SERVICE BULLETIN # SB015

SUBJECT: SMART-STEER 2.0 Axle with 702887 Steer Arm

STEER ARM WELDING SPECIFICATIONS

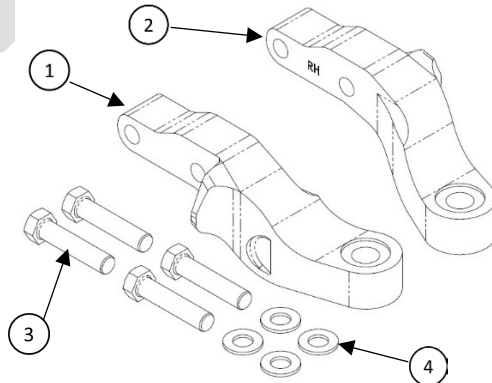
Based on feedback from our customers and recent analysis, Dexter Heavy Duty has identified an ongoing issue with the 702887 steer arm configuration on the Smart-Steer 2.0 self-steer axles. Under certain repeated heavy loading conditions, the steer arm has the potential to fail.

1. Remove the existing steer arms and mounting hardware.
2. Clean mounting surface and surrounding surfaces to prepare for mounting of the new bolt-on steer arm and additional welds.
3. Grind a 3/16" chamfer along the mounting face edge (see page three for location & detail).
4. Mount new design steer arms (Part # 703293-LH/RH) with supplied hardware and torque to 400 ft-lbs.
5. Add welds as shown on page three of this bulletin.

ITEM NUMBER	QUANTITY	PART NUMBER	Description
1	1	703293-LH	B/O steer arm LH
2	1	703293-RH	B/O steer arm RH
3	4	703100	BOLT 3/4-16UNF 3.25"lg GR8 Yellow Zinc (VMI)
4	4	701810	WASHER FLAT .75" MC2 GR8 (VMI)
Not Shown	1	0150425	LOCTITE®, BLUE 242, 0.5ml
